**PZ&B Staff Combination Memo: Town Council Development Review and Architectural Commission**

**SUBJECT:** ARC-23-110 (ZON-23-079) 2773 S OCEAN BLVD (COMBO)

**MEETING:** AUGUST 09, 2023 TC  
AUGUST 23, 2023 ARCOM

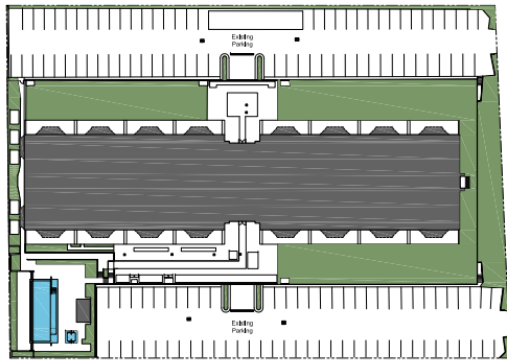
**VARIANCE 1**, the applicant is proposing to install two new entry canopies along the north and south sides of the site to provide shelter from the parking areas towards the main building entrances. Each canopy is measured at 31' in width and 15' in depth and are flanked by two planters. The 450 SF (each) of the existing entrance canopies count towards the overall lot coverage of the site, which is currently nonconforming. The canopies have a clearance height of 7'-6". They are proposed to be in Sunbrella 'Sea Mark Oyster' fabric; the structural frame and vertical support posts are in 4" members that are powder-coated white.

PROPOSED LANDSCAPE OPEN SPACE DIAGRAM  
(Phase 2)

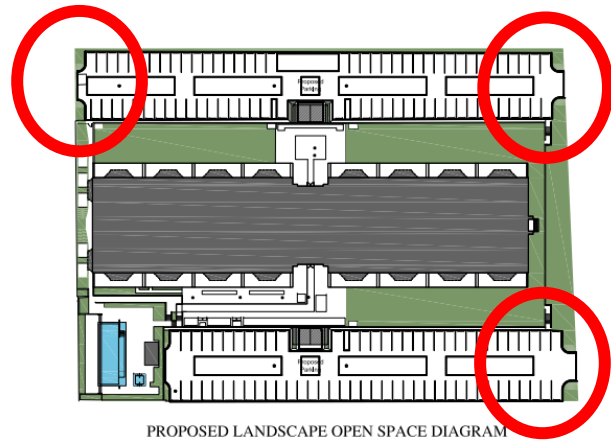
**VARIANCE 2**, the applicant is demolishing the existing north and south parking areas, capturing additional parking, and installing new landscaping. With the combination of Phase 1, and this scope, the Carlyle house is removing nearly 100% of the 'open space' of the site which includes the parking areas. PZB applies the nonconformance section of the Code to maintain the site to today's zoning requirements. For multifamily uses, the minimum landscaped open space is 35 percent. The applicant is proposing to retain an existing-nonconforming landscape open space of 21%, where 35% is required, and 20% is existing. The applicant is improving the amount of greenspace on the site by 1%, mostly at the three 'corners' (NW, NE, and SE) of the site along with

the more efficient restriping that increased the number of parking spaces. In addition to the new landscaping, the parking area are proposed to be improved to pavers set in a herringbone pattern in grey hues in lieu of the existing asphalt field.
